WINNEBAGO

NHTSA Safety Recall 26V-498 | Transport Canada 2026-372

SUBJECT: **Campaign # 208 – Generator Unintended Self-Start 52L**

Step 1 – Download the PCI Updater App

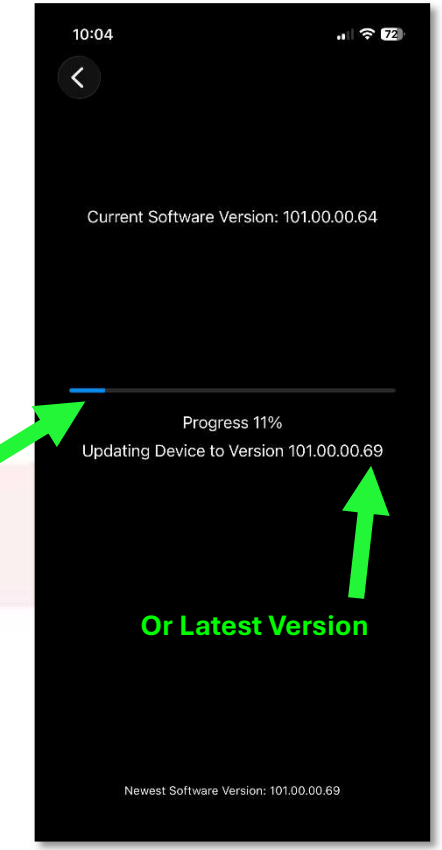
Certain Winnebago vehicles equipped with Precision Circuits touchscreen displays running firmware version 101.000067 or earlier, contain a software defect that may cause the generator to start without operator input.

a. Download the Precision Circuits, Inc. "**PCI Updater**" app from the Apple App Store or Google Play Store on your phone or tablet.
